**State Implementation Plan (SIP) to Address Requirements of the Federal Regional Haze Rule**

## **BART Requirements for Wisconsin Sources – Response to Public Comment**

### **I. Georgia Pacific BART Requirements**

Table. Comparison of Emission Levels and Control Required in Meeting the 12 Month Mass Cap.

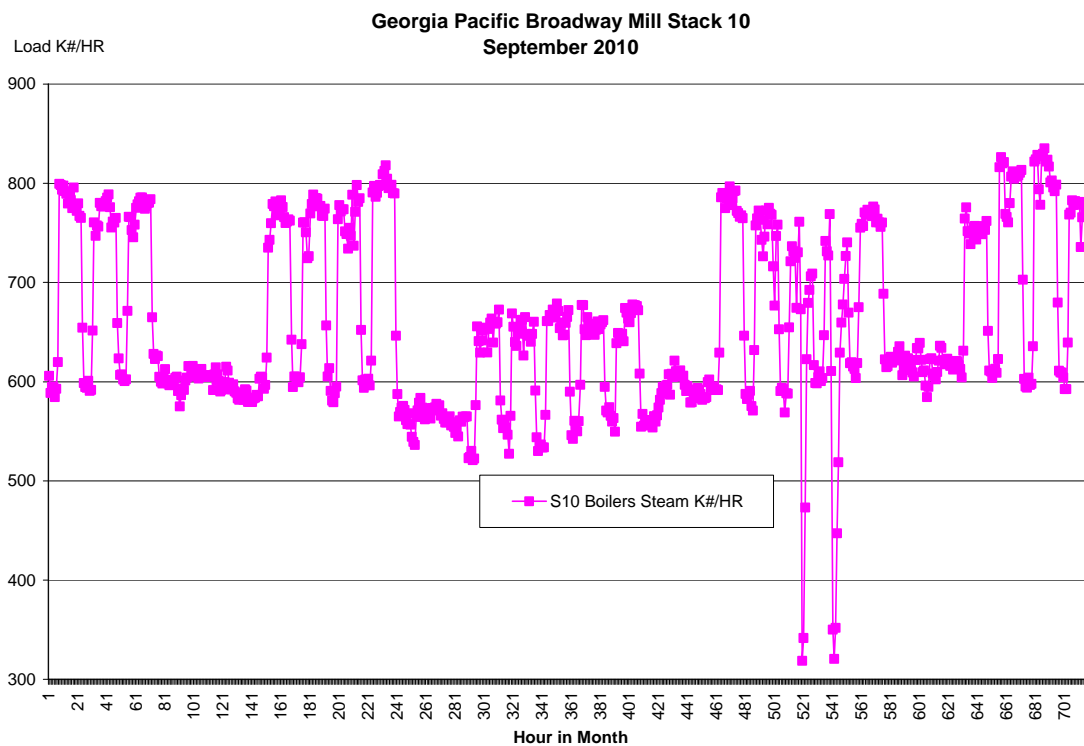
**Comment 5.1:** The Federal Land Managers and Sierra Club commented that a mass cap does not represent BART level of control; i.e. the BART control levels are may not be achieved while the boilers are operating at low loads.

Establishing mass caps from the baseline year average emissions will ensure ongoing overall control levels consistent with BART control. For both SO<sub>2</sub> and NO<sub>x</sub>, emission levels for stack S10 remain fairly constant from 2002 to 2010, summarized in the table below. This information shows that there has been no extended period of low load operation significantly affecting overall operations from year to year. In looking at the baseline year average emissions the BART controls result in an average 81% and 72% control of SO<sub>2</sub> and NO<sub>x</sub> emissions, respectively. Based actual historic emissions the average SO<sub>2</sub> control will potentially range from 79% to 82%. A further case is looked at where the baseline year average emission rates are multiplied by the low and high heat inputs demonstrated for the stack S10 system to further check control sensitivity – using the baseline year emission rate would be the same basis as evaluating control levels under an emission rate limitation. Here potential control levels range from only 78% to 82%. This evaluation shows that overall control levels based on normal historic operation are likely to be greater as much as less than the BART determined control efficiencies. In fact, Georgia Pacific will have to pursue greater reductions they increase facility production and steam requirements. These same conclusions hold true for the NO<sub>x</sub> BART control levels. These same conclusions are supported by the most recently available data for 2010 which shows required control levels for both SO<sub>2</sub> and NO<sub>x</sub> are substantially the same as for BART.

On a daily basis, Georgia Pacific will have to meet control levels consistent with the BART control levels. A chart of stack S10 steam load for stack S10 shows the range between high and low loads are very consistent and that daily cycling is consistent as well. This supports that there is not one or a few types of load situations where Georgia Pacific can significantly curtail load. Basically, the boiler normal operations are consistent and therefore reflected by the long term average operations. Therefore the mass cap based on average operating levels accounts for the range of demonstrated load swings over short periods. Further because of the frequency of operating at both low and high loads Georgia Pacific cannot target the curtailment of control equipment operation at any one specific level without significant impact. This information supports the conclusion that Georgia Pacific will not be able to substantially alter the actual efficiency of control equipment or curtail emission reduction measures responding to BART on a prolonged basis.

Ultimately, it is prudent for Georgia Pacific to control at both high and low loads to ensure that unplanned or higher production levels than normal can be accommodated as needed. However, it is worth evaluating the impact to visibility in the event control levels are less than BART. If Georgia Pacific decides to reduce control levels at lower loads then reductions must be made up at higher load levels. Since high loads are the periods of higher emissions increasing the control efficiency during these periods will have the greatest benefit in reducing visibility impacts. At lower loads, the emissions have a lower initial visibility impact than at the higher loads. Therefore this potential approach to BART controls has greater overall benefit to reducing visibility impacts.

For these reasons combined, the Department maintains that a mass cap ensures a BART level of control overall and potentially a higher level of control at the times of greatest visibility impact.
